CITY PLAN COMMISSION**THURSDAY, MARCH 6, 2025****FILE NUMBER:** S245-101**SENIOR PLANNER:** Hema Sharma**LOCATION:** terminus of Matilda Street, south of Sandhurst Lane**DATE FILED:** February 6, 2025**ZONING:** MU-3**CITY COUNCIL DISTRICT:** 9**SIZE OF REQUEST:** 12.03-acres**APPLICANT/OWNER:** Mindy Jameson, Oncor Electric Delivery Company, LLC.**REQUEST:** An application to create one 12.03-acre lot from a tract of land in City Block 5403 on property located at terminus of Matilda Street, south of Sandhurst Lane.**SUBDIVISION HISTORY:** There has been no recent platting activity within close proximity to this request.**STAFF RECOMMENDATION:** The request complies with the requirements of the MU-3 Mixed Use District 3; therefore, staff recommends approval of the request subject to compliance with the following conditions:**General Conditions:**

PRELIMINARY PLAT OF
Oncor Business
Park
LOT 1, BLOCK 5403

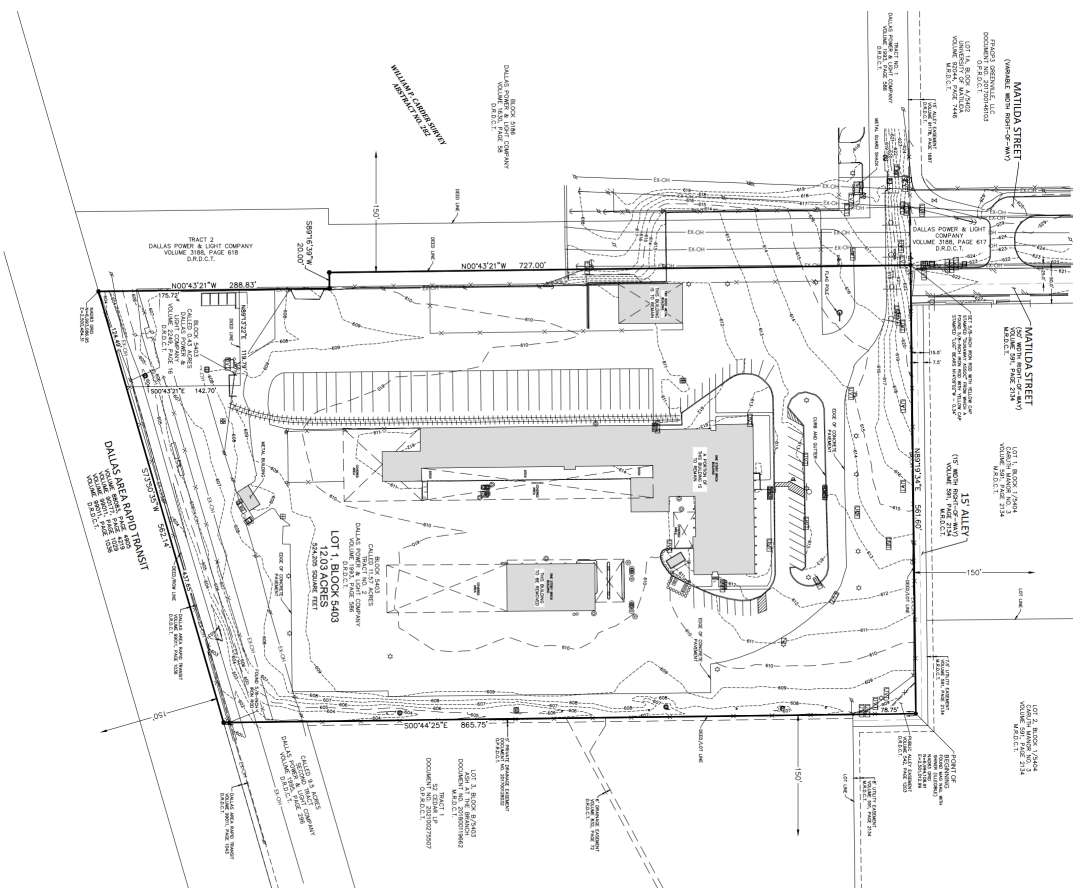
15. On the final plat, dedicate a 15-foot by 15-foot Alley Sight Easement at north side Alley and east side Alley. *Section 51A-8.602(e)*
16. Provide a turn-around per the City of Dallas Standards at the end of Maltida Street. *Section 51A-8.506(b)*
17. Provide minimum alley ROW at the alley bend per City of Dallas Standard Construction Details File 251D-1 Page 4002

18. Prior to final plat, submit a completed final plat checklist and all supporting documents.
19. On the final plat, show recording information on all existing easements within 150 feet of the property.
20. On the final plat, show all additions or tracts of land within 150 feet of the property with recording information. Platting Guidelines.

21. Engineer must furnish plans for water and sanitary sewer. Developer must furnish a contract for water and sanitary sewer. Sections 49-60(g)(1) and (2) and 49-62(b), (c), and (f).
22. Additional design information is required for assessment. Site plan must be submitted showing proposed development, building finished floor elevation,

development, existing mains – including downstream manhole, and proposed water and wastewater service locations. Submit water/wastewater engineering plans to 320 E. Jefferson Blvd., Room 200, Attention: Water and Wastewater Engineering.

23. Water and Wastewater main improvements is required by Private Development Contract. Submit water/wastewater engineering plans to 320 E. Jefferson Blvd., Room 200, Attention: Water and Wastewater Engineering.
24. Existing and any proposed Water and Wastewater Easements must be shown and/or increased to conform to current design standards. **Notice:** Minimum DWU easement size 20' for one utility and 25' for both water and sewer. Larger diameter or deeper mains may require additional width.

25. Prior to final plat, compliance with City's street lighting standards including illumination standards, material, installation, and activation per Street Design Manual.
26. On the final plat, identify the property as Lot 1 in City Block C/5403.
